TOWN OF MEDWAY

DESIGN REVIEW COMMITTEE

September 11, 2024

Andrew Catania, Vice President, Development Acquisitions
VC Renewables
110 Edison Place, Suite 312
Newark, NJ 07102
Re: DRC Letter of Recommendation – Medway Grid, LLC - Battery Energy Storage System

The DRC recommends the pattern of “Ledge Stone” in the grey color tone as proposed by the applicant and illustrated here in figure 1

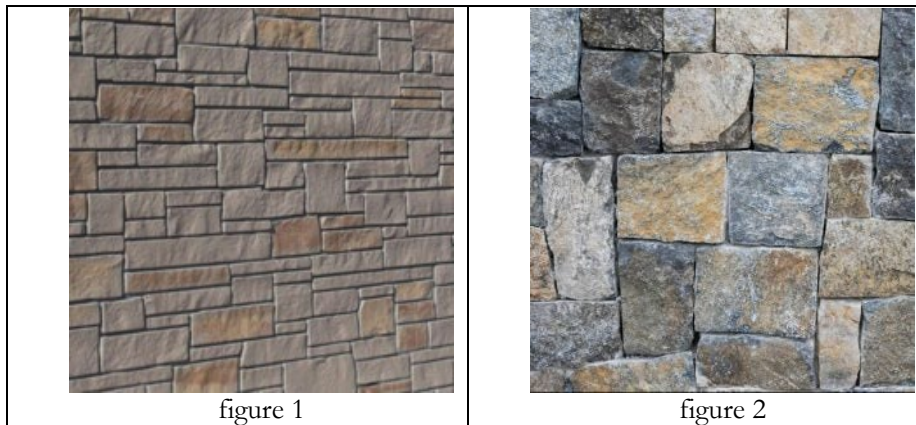
- This pattern includes a varied color pattern to simulate natural stone. It has been indicated to the DRC that the coloration to this wall system is done in the field at the time of installation and can include assorted color tones and shades.
- The DRC recommends in addition to the grey and oxidized iron color, a darker gray color be included to more closely replicate the stones found in the area as illustrated in figure 2.
- This coloration should be randomized and varied, so as not to develop a pattern and appear artificial.
- The coloration is meant to be permanent, and the maintenance plan should assure it remains.
- The maintenance plan should also provide solutions for vandalism and graffiti as well as damages of any kind that effect or alter the appearance of the material.
- The joining columns and headers should match the grey color recommended.
